Re: Recall Number 99V-333

Please find a copy of the draft Technical Service Bulletin (TSB) that Mitsubishi Motor Sales of America, Inc. (MMSA) will be using for the above referenced recall (the proposed owner notification letter is on page 11 of the attachment). Please review the TSB and owner letter at your earliest convenience and advise us of any comments or changes you would like. Mitsubishi Motor Manufacturing of America reports that they have not received an acknowledgement letter from you; however, the NHTSA web site lists the number as 99V333000. If our information is incorrect, please advise by return. MMSA's recall number will be SR-00-001, Battery Cable Harness Safety Recall Campaign.

<b>SUBJECT: BATTERY CABLE HARNESS — SAFETY RECALL CAMPAIGN</b>			No: <b>SR-00-001</b>
			DATE: <b>January, 2000</b>
			MODEL: <b>See below</b>
CIRCULATE TO:	<input checked="" type="checkbox"/> GENERAL MANAGER	<input checked="" type="checkbox"/> PARTS MANAGER	<input checked="" type="checkbox"/> TECHNICIAN
<input checked="" type="checkbox"/> SERVICE ADVISOR	<input checked="" type="checkbox"/> SERVICE MANAGER	<input checked="" type="checkbox"/> WARRANTY PROCESSOR	<input checked="" type="chec

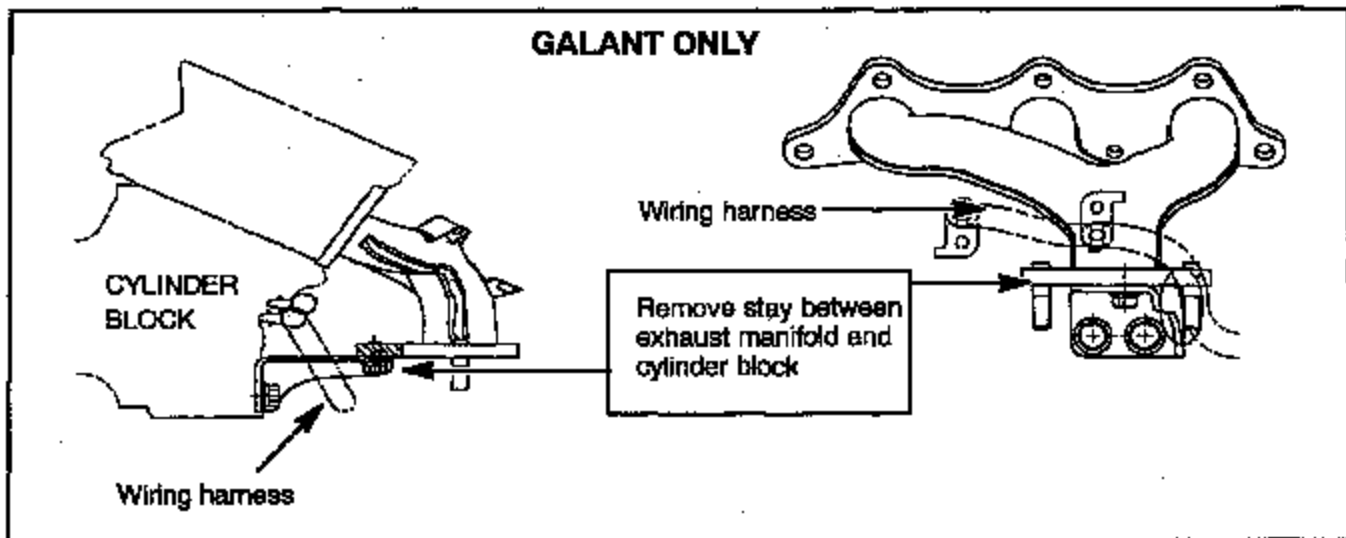
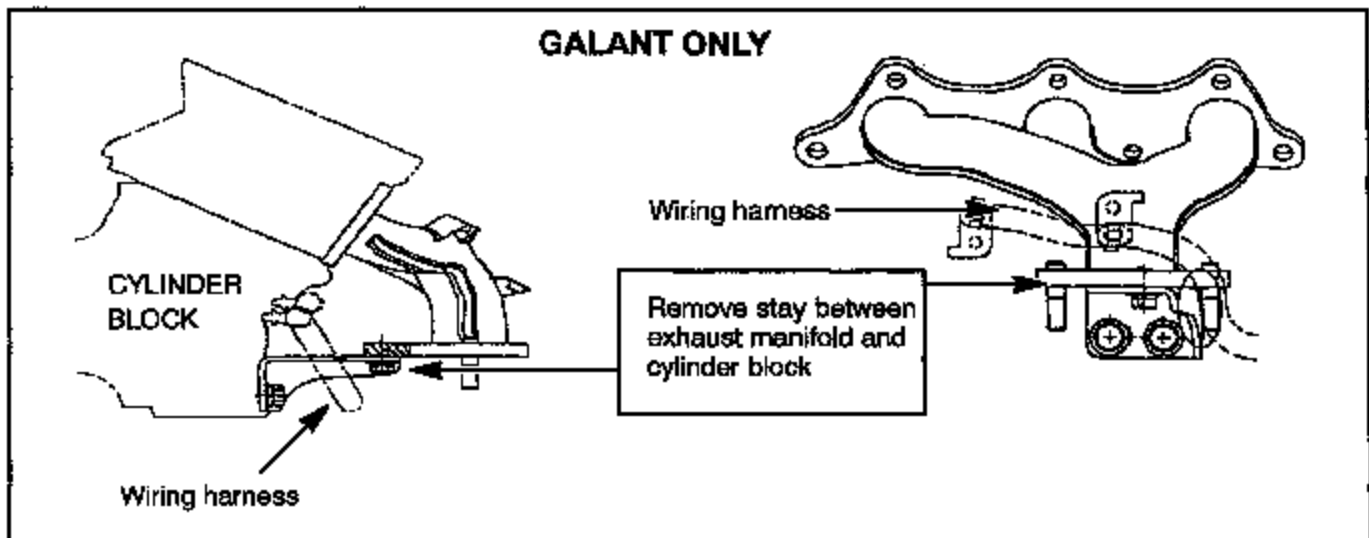
- (1) **GALANT ONLY:** Remove the 3 bolts securing the stay (bracket) to the cylinder block and exhaust manifold. Unbolt the stay from the engine block. Remove and discard the stay.

- (1) **GALANT ONLY:** Remove the 3 bolts securing the stay (bracket) to the cylinder block and exhaust manifold. Remove the stay from the engine block and discard it.

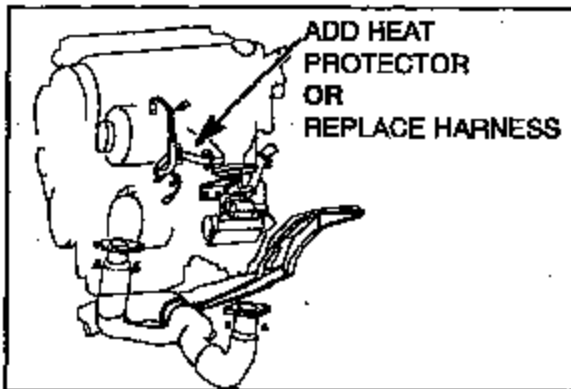
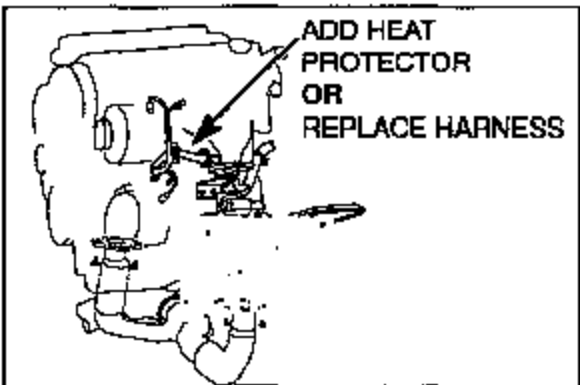
Insert a small screwdriver into the clip in the location shown and gently pry the clip to open.

Insert a small screwdriver into the clip in the location shown and gently pry the clip to open.

- If the harness wiring is not exposed through any holes in the corrugated tubing, install the Heat Insulator Kit. Go to Step 2 for Heat Insulator Kit installation instructions.
- If the harness wiring is exposed through holes in the corrugated tubing, **replace** the battery cable harness with the new harness listed in the PARTS INFORMATION section of this bulletin. Go to Step 3 for battery cable harness replacement instructions.

- If the harness wiring is **not** exposed through any holes in the corrugated tubing, install the Heat Insulator Kit. Go to Step 2 for Heat Insulator Kit installation instructions.
- If the harness wiring is **exposed** through holes in the corrugated tubing, **replace** the battery cable harness with the new harness listed in the PARTS INFORMATION section of this bulletin. Go to Step 3 for battery cable harness replacement instructions.
